ROCK SLOPE STABILIZATION

TSP 67-1
TACONIC STATE PARKWAY
(KITCHAWAN ROAD-BALDWIN ROAD)
WESTCHESTER COUNTY

SUBJECT TSP 67-1, TACONIC STATE PARKWAY, KITCHAWAN RD. TO BALDWIN RD.
WESTCHESTER COUNTY, PIN 8107.00-301, RECOMMENDATIONS FOR
REMEDIAL TREATMENT OF ROCK SLOPES

SUBJECT TSP 67-1
TACONIC STATE PARKWAY (KITCHAWAN RD. - BALDWIN RD.)
WESTCHESTER COUNTY, P.I.N. 8107.00-301

Figure No. 12 - Northbound Station N378+00₊, right.
Note that the inadvertently well aligned drill holes on the right side of the photograph produced a uniform plane of rupture. Poorly aligned holes in the center and left side of the photograph produced a ragged and uneven slope.

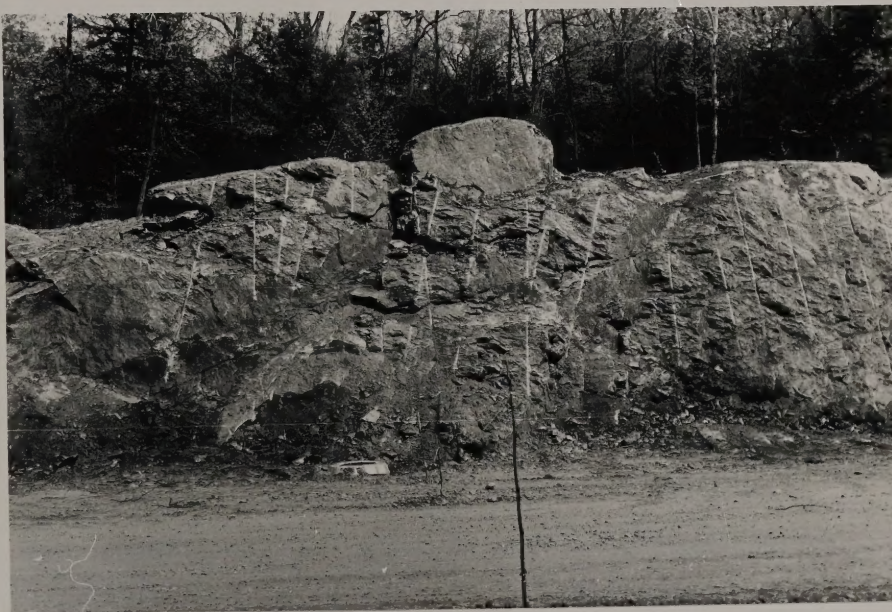
The extensive amount of remedial treatment required to stabilize the rock slopes on this project infers that rock of poor quality was encountered and/or the drilling and shooting was poorly controlled. It is true that there is some badly jointed, blocky and weathered rock on the contract, however, proper drilling and shooting methods would have greatly reduced the problems. Mr. V. Bryant's report of January 21, 1971, made note of the fact that under similar rock conditions, areas where presplitting was and was not required showed no appreciable difference in results. He stated, "It appeared that the same procedures were followed whether presplitting was required or not." He further stated that, "Evidence points to the fact that since the Contractor was permitted to deviate from the specification in some areas, operations in other areas where presplitting was required were less than satisfactory." These statements are illustrated in Figure Nos. 8 through 12. At locations shown in Figure Nos. 8 and 9, the presplitting requirement had been waived. At locations shown in Figure Nos. 10 and 11, however, the presplitting requirement was in effect. Figure No. 12 is taken at Station equality N378+00+ = "NE" Ramp Station 13+14+, right. This photograph was taken in the transitional region between areas where presplitting was and was not required. In the left third of the photograph, presplitting was required. In the right third of the photograph, the slope is more uniform

even though it was not presplit according to specifications. In this case, the Contractor inadvertently maintained better control of the drilling and as a result produced a more uniform rock slope.
